Director's Independent Design and CD-2/3 Review of the Muon g-2 Project

June 17-19, 2014

Issued – June 25, 2014

The Project presented the BO vs BA curve which is provided below.

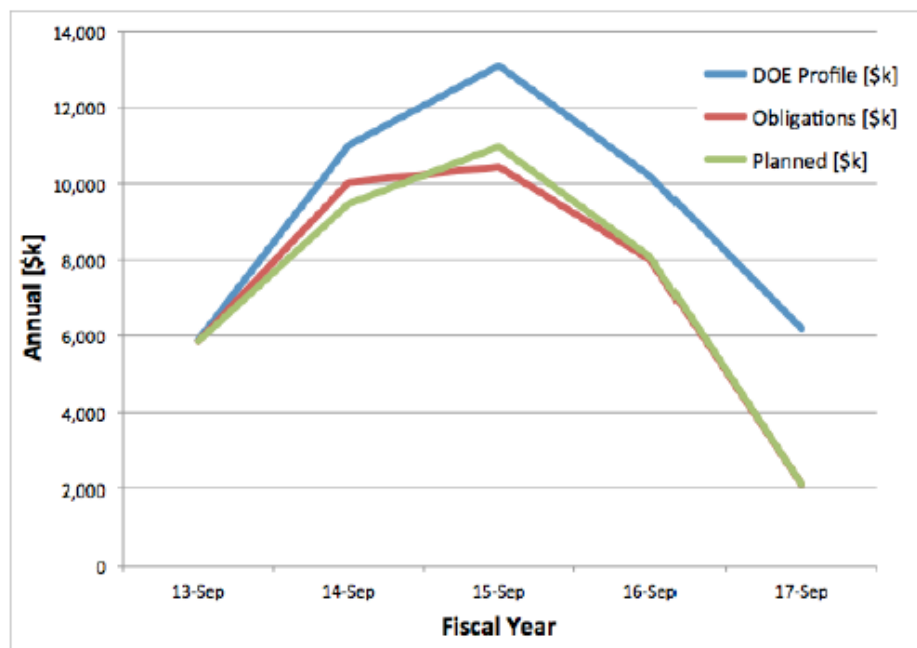
- The Muon G-2 Project's proposed total project cost (TPC) is \$46.4M. This includes \$9.9M of contingency and \$36.5M of TEC. Half of the project's TEC is associated with accelerator modifications. The Project's contingency is 27% of TPC and 37% of remaining cost to go.
